**Concept State Significant Development Application – SSD 18\_9579  
Sydney Metro City & Southwest – Crow's Nest Over Station Development**

**Concept State Significant Development Application – SSD 18\_9579  
Sydney Metro City & Southwest – Crows Nest Over Station Development**

#### COMMENTS ON THE EIS

**Figure 2 – Proposed Crows Nest OSD building envelope (axonometric diagram) and future high-rise development in the St Leonards Town Centre (Sydney Metro’s EIS)**

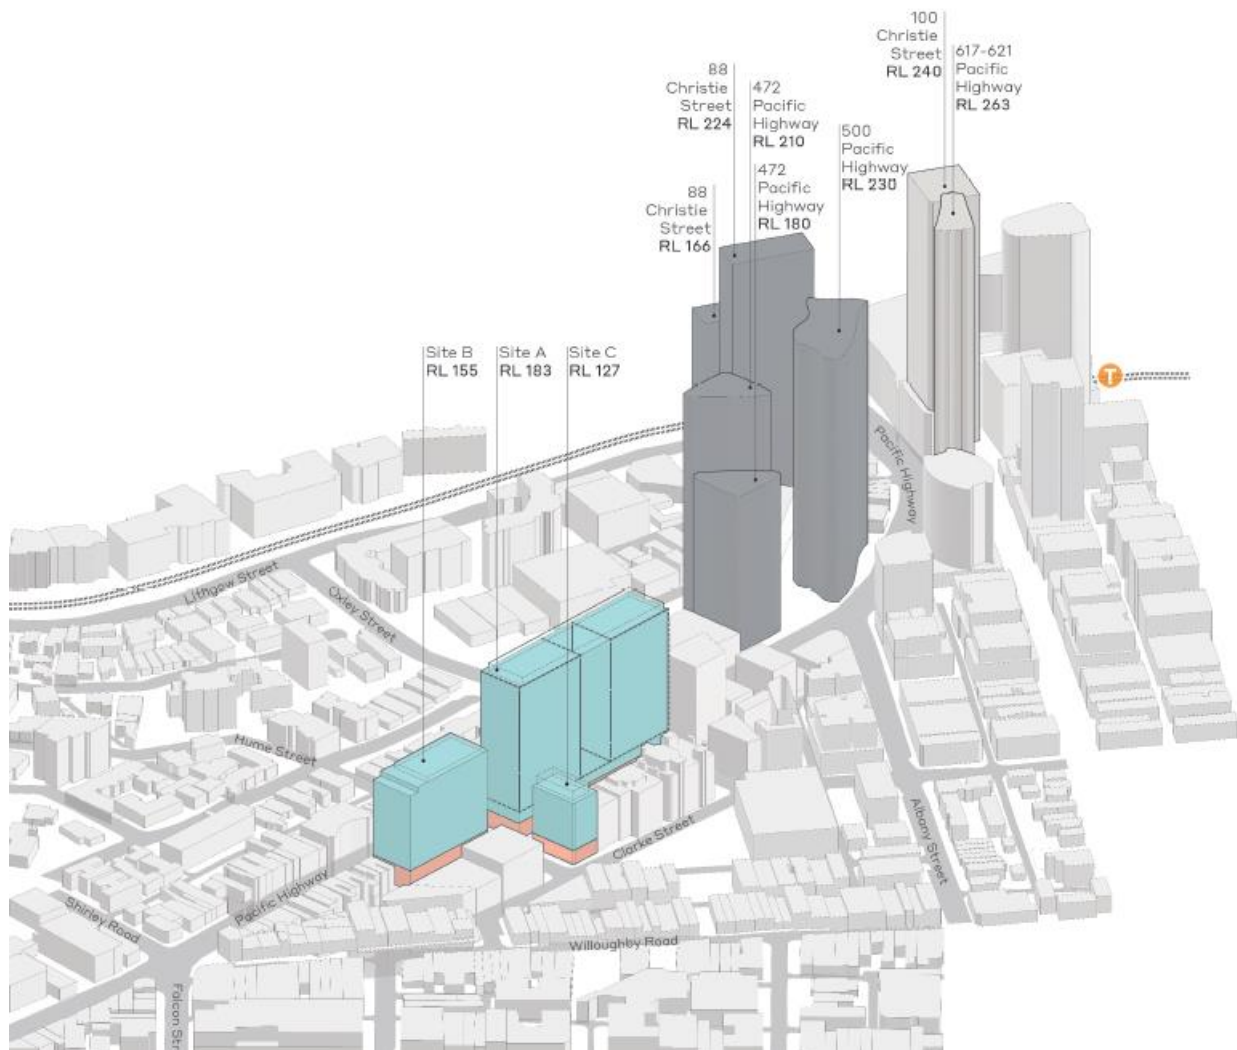
### **MISLEADING IMAGE**

This is Sydney Metro’s axonometric diagram (at 45 degrees angle) that ignores perspective and gives the reader the incorrect impression that the proposed buildings over the Crows Nest Station are relatively small when compared to future and existing high-rise developments in St Leonards.

The truth is that the image distorts reality. In a true perspective the tower at 472 Pacific Highway is at RL 180 roughly the same as the two 27 storey towers (RL 183) and as a result the two towers would look very much taller than depicted on this distorted image. Refer to “What Sydney Metro is Now Proposing” on the front page for a more realistic aspect.
